Reference: Operations Plan Permit Modification – Chimney Drain Letter
Retired Ash Basin (RAB) Ash Landfill
Duke Energy - Allen Steam Station, Belmont, North Carolina
S&ME Project No. 1356-10-009A, Task 05
S&ME Engineering License No. F-0176

CHIMNEY DRAIN - STAGE 1
RAB ASH LANDFILL
 ALLEN STEAM STATION
 BELMONT, NORTH CAROLINA

SCALE: N.T.S. PROJECT NO. 1356-10-009A ENGINEERING LICENSE NO. F-0176	DATE: 6-9-11 DRAWN BY: KB CHECKED BY:	 9751 SOUTHERN PINE BLVD. CHARLOTTE, N.C. 28273 (704)523-4726 WWW.SMEINC.COM	CHIMNEY DRAIN - STAGE 2 RAB ASH LANDFILL ALLEN STEAM STATION BELMONT, NORTH CAROLINA
FIGURE NO.		2

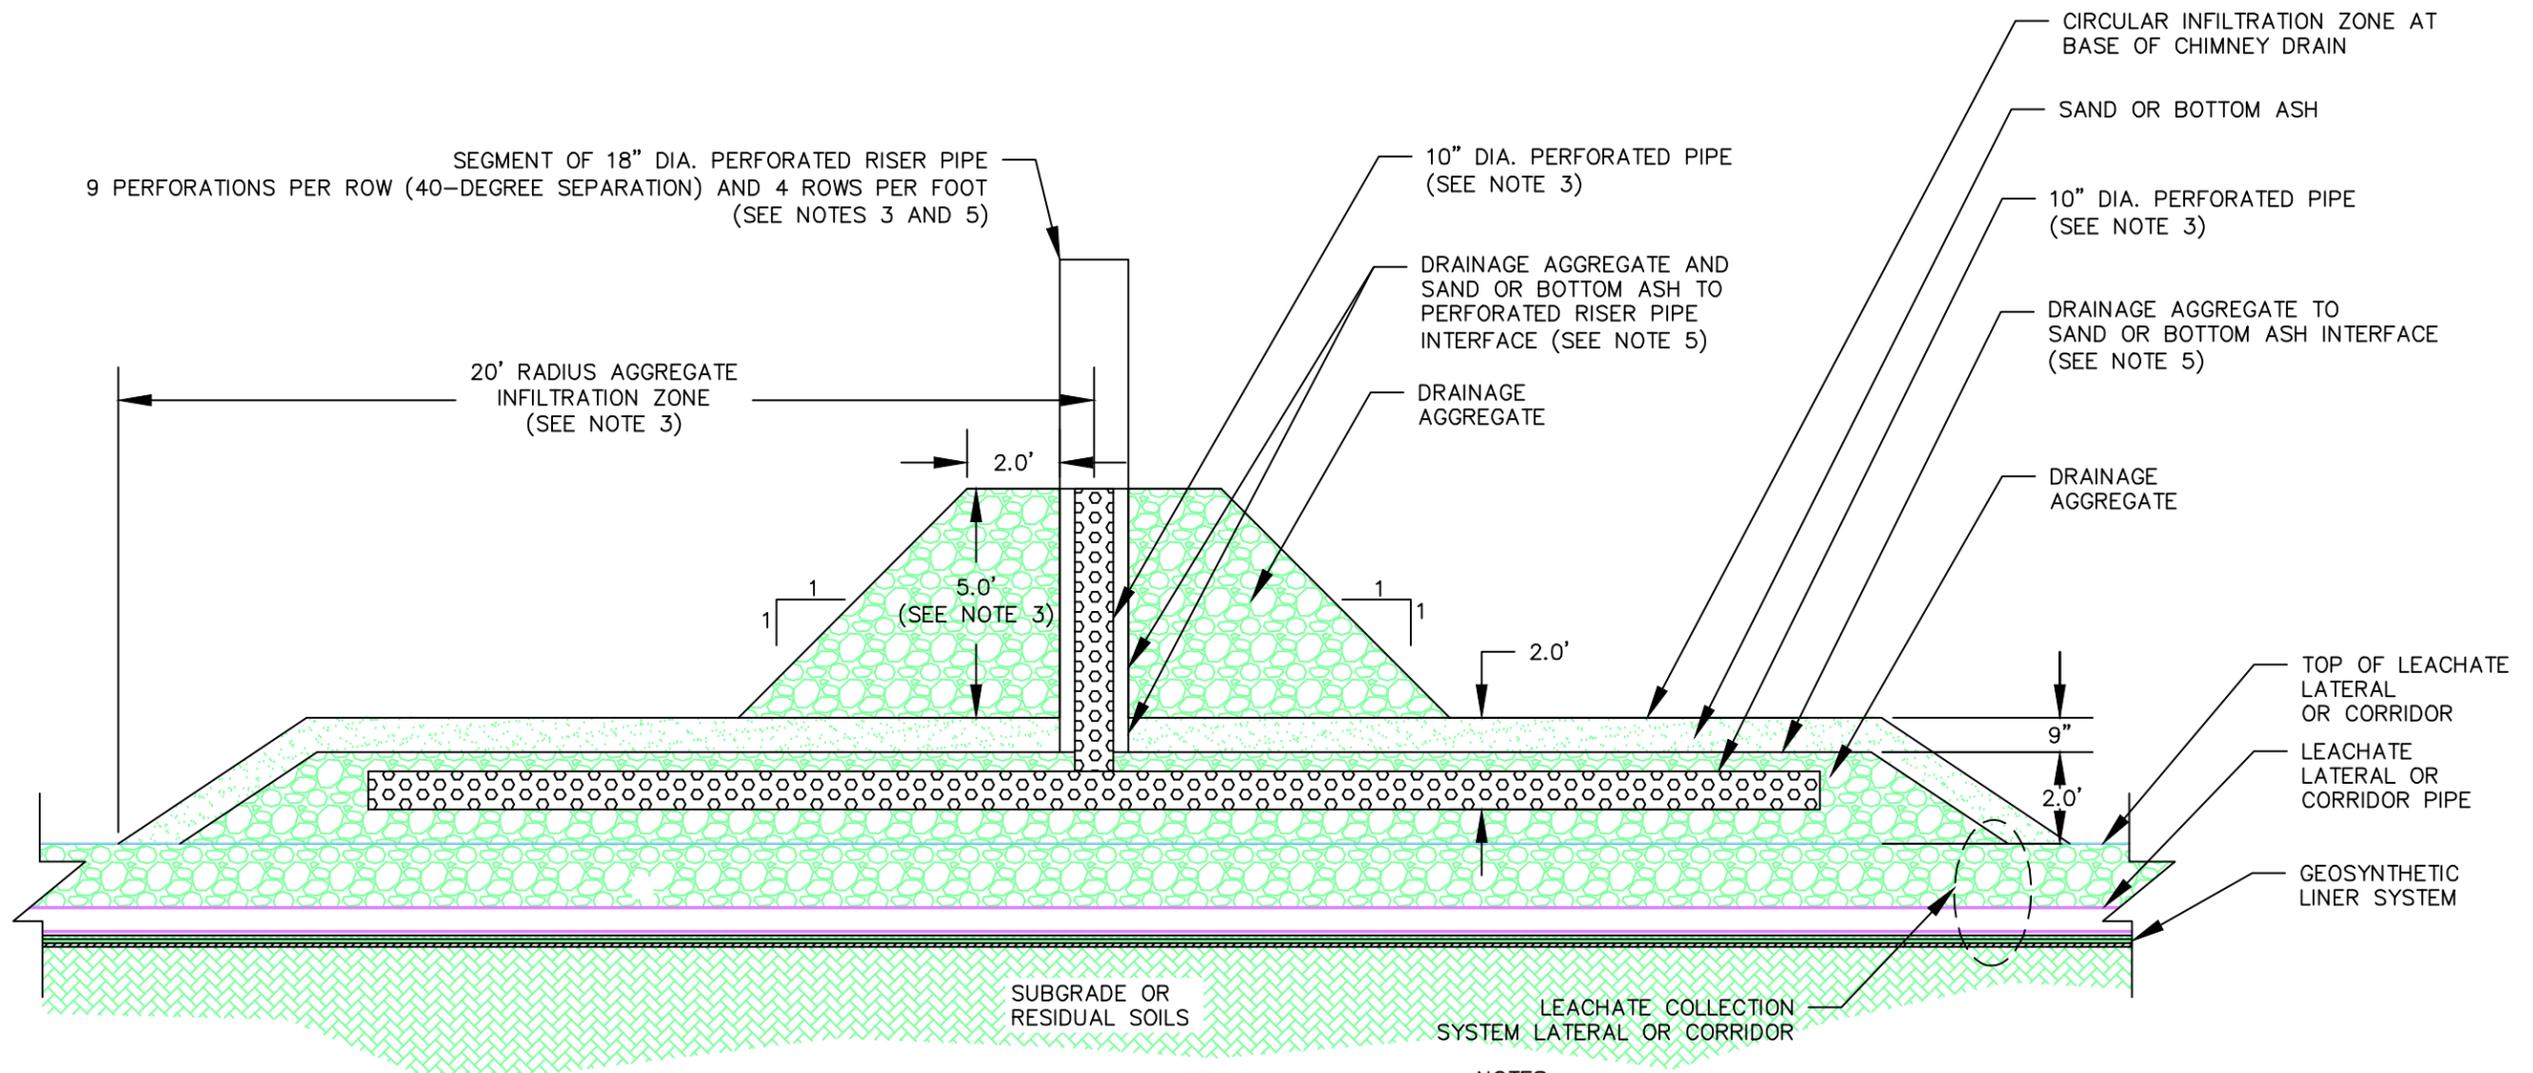
The intent of the chimney drain addition is to improve contact water management within the landfill by providing a more direct drainage path from the landfill deck and active face areas to the leachate collection system (LCS). A general chimney drain plan is provided in the attached Figures 1 and 2 to illustrate the chimney drain concept.

The proposed chimney drains will generally consist of horizontal perforated HDPE pipes surrounded by a drainage aggregate media at the chimney drain base functioning as an infiltration zone over the LCS system. As operations progress, vertical perforated pipe will be connected to extend the chimney drain upward to the top deck and active face. Pipe extensions will be surrounded with a drainage aggregate media. Pipe fittings may be utilized to extend chimney drains to the active face.

The proposed chimney drains will be located and installed directly over the existing LCS laterals or center corridors to provide a more direct drainage path to the LCS. However, chimney drain pipes shall not be directly connected to LCS lateral or header pipes. We note that the proposed chimney drains will be placed on top of the existing liner system LCS header, corridors, and protective soil layer adjacent to the LCS header and corridors.
